N5242AS-02A

S E R V I C E N O T E

Supersedes:
N5242AS-02

N5242AS PNA Series Microwave Network Analyzers

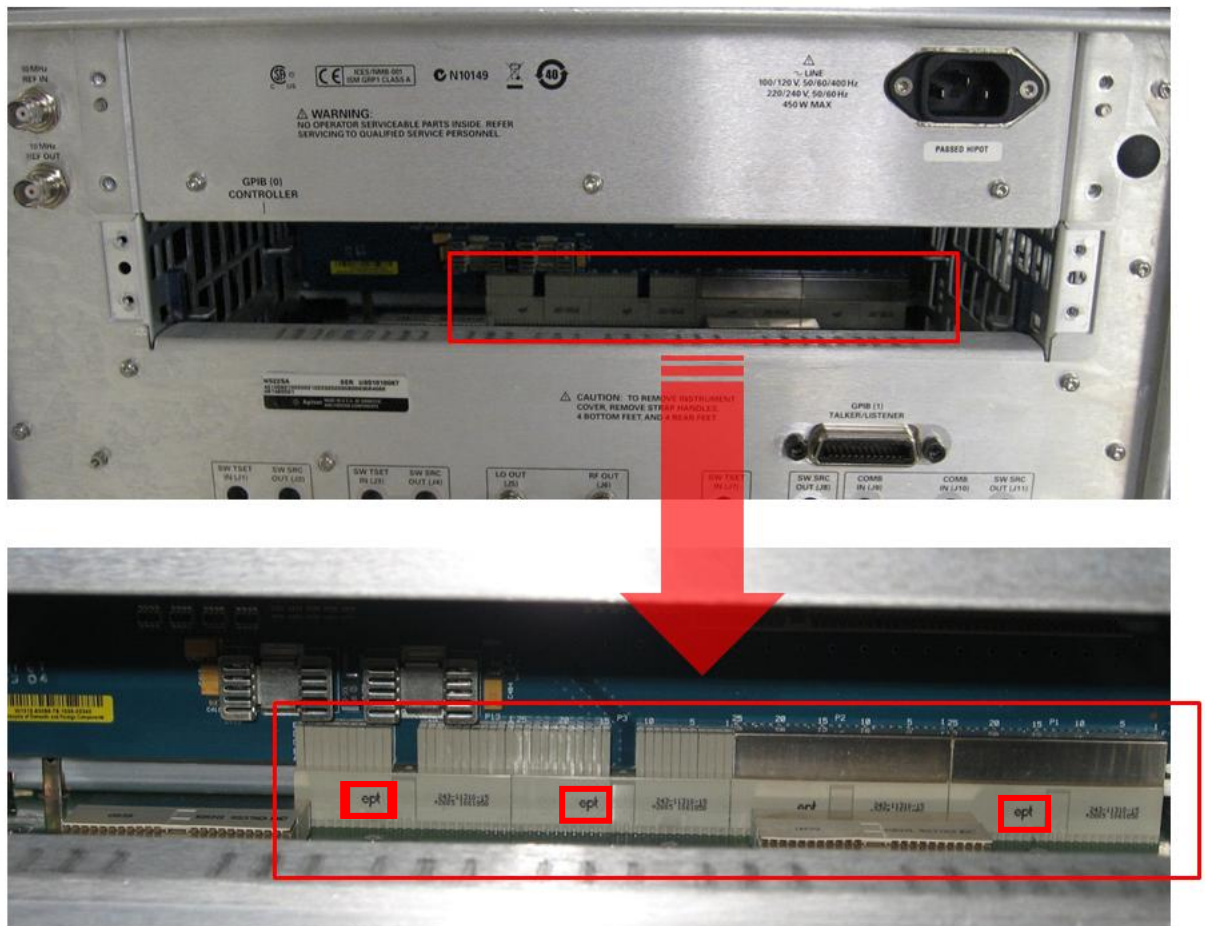
1. Remove the CPU assembly from the analyzer's rear panel. Refer to the PNA Service Guide chapter 7 section titled, "Removing and Replacing the CPU Board Assembly" for removal and reinstallation procedures. To view the online Service Guide, see the numbered list on the next page for instructions.
2. As per the photo below, inspect the system motherboard connector to see if it has one or more "ept" logos.

3. If the connector has one or more “ept” logos, return the analyzer to Agilent for replacement of the system motherboard. If the connector does not have one or more “ept” logos, email ctd-soco_support@agilent.com, providing the analyzer model and serial number and details of the malfunction symptoms.
